PROFESSIONAL RECOMMENDATION MEMORANDUM

Project Name: Engineering Support Services and Recommendations for Roadside Safety Issues/Problems for Member States

Task 21-08: Lengthening Splice Bolt Slots in Thrie Beam Transition

DATE: November 08, 2021

Figure 1. Schematic of Bridge Rail Transition

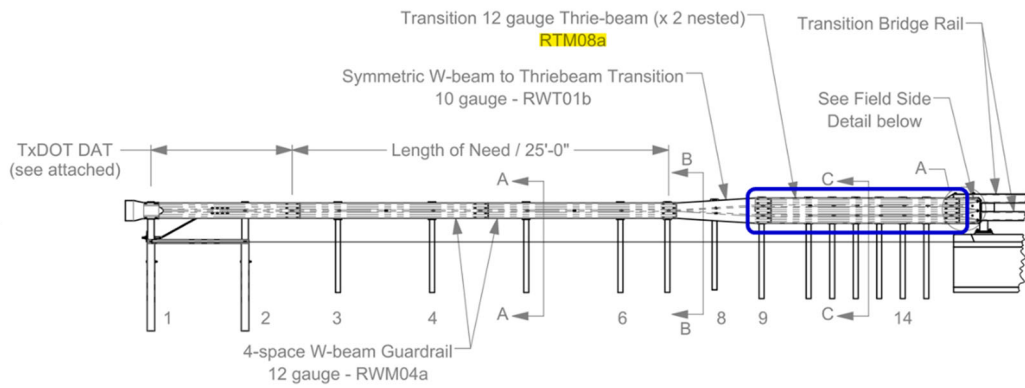
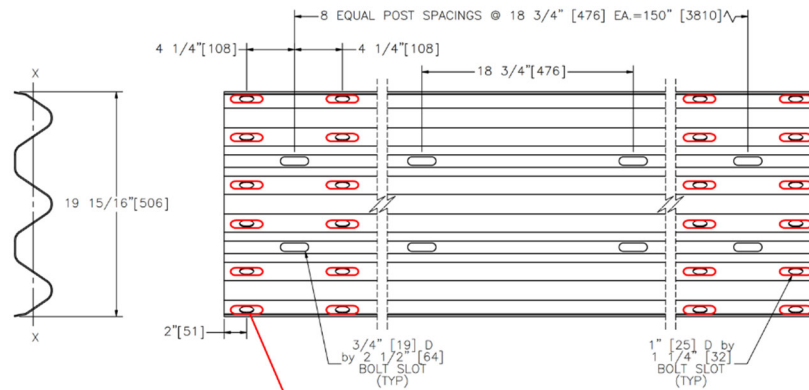
The purpose of this project was to investigate the lengthening splice bolt slots on thrie beam guardrail elements on the new Alaska 2-Tube Bridge Rail Transition (Test Report No. 608331-4-6). Figure 1 shows an overview of the bridge rail transition. The thrie beam guardrail highlighted in the figure has two lines of splice bolts at the connection ends. The original length of the slots for splice bolts is 1 1/4 in. Alaska DOT would like to increase the length of these slots to 3.0 inches to make it easier to install and construct the transition in the field.

Figure 2. Possible Travel in Slots

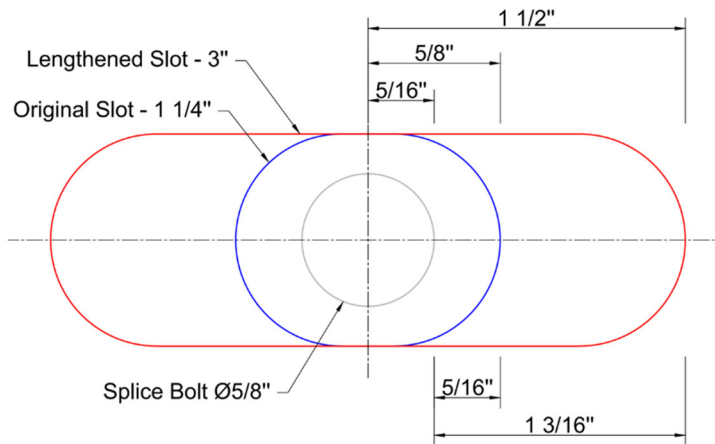
Figure 2 shows an enlarged view of the splice bolt in the slots for the different lengths. The thrie beam will subject to crash loads resulting in lateral and tension forces on the thrie beam rail element. Lengthening the length of the slots will accommodate more lateral displacement in the transition rail element before the tension force is transferred to adjacent rail elements. As shown in Figure 2, the excess travel of the guardrail bolt centered in the slot in thrie beam in original 1 1/4 in. long slots are 5/16 in. Whereas for the lengthened 3 in. long slot, the possible travel is 1 3/16 in. More travel of the thrie beam will induce more deformation of the thrie beam at the center of the span. Figure 3 depicts the theoretical lateral deformation of the thrie beam at the center of the span for the two different lengths of slots. The deformed thrie beam is simplified as a triangular shape.

Figure 3. Deformation of Thrie Beam with Different Length of Slots

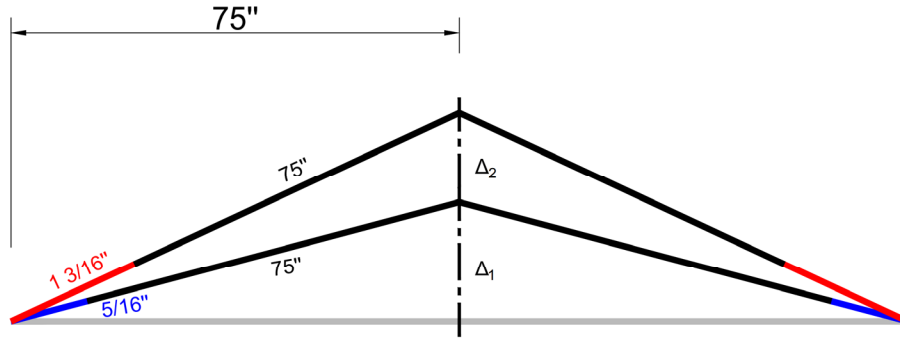
The deformation of the thrie beam, Δ_1 and Δ_2 , can be calculated as:

$$\Delta_1 = \sqrt{(75 + 5/16)^2 - (75)^2} = 6.85 \text{ in.}$$

$$\Delta_1 + \Delta_2 = \sqrt{(75 + 1 \frac{3}{16})^2 - (75)^2} = 13.4 \text{ in.}$$

$$\Delta_2 = 13.4 - 6.85 = 6.55 \text{ in.}$$

As shown, lengthening the slots from 1 1/4 in. to 3 in. will increase the deformation of the thrie beam by 6.55 in. at the center of the span. The deformation of the thrie is almost doubled with the longer slots. Therefore, lengthening the splice bolt slots to 3 in. could adversely affect the crash performance of the as-tested thrie beam transition.

Based on this analysis, the lengthened splice bolt slots will induce almost doubled deformation to the thrie beam. Also, the end distance from the slot hole to the end tip of the thrie beam will be decreased to 1/2 in. with lengthened slot holes. Therefore, it is not recommended to use the long slots for this thrie beam transition without performing full-scale crash testing in the immediate transition area for both the small car and pickup truck tests (MASH Test 3-20 and 3-21, respectively).

Figure 4. End Distance of Thrie Beam Transition with Lengthened Slot Hole

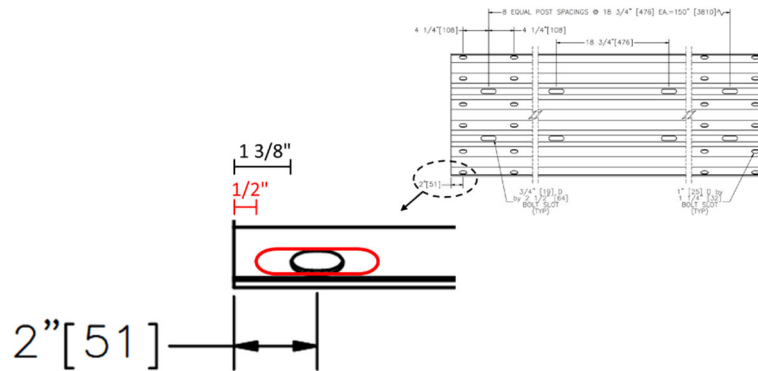
The end distance from the slot hole to the end tip, as shown in Figure 4, could be another issue affecting the performance of the thrie beam transition. The end distance with the lengthened slot hole will be decrease to 1/2 in. from 1 3/8 in, which could be critical when considering the manufacturing tolerance of $\pm 1/2$ in.
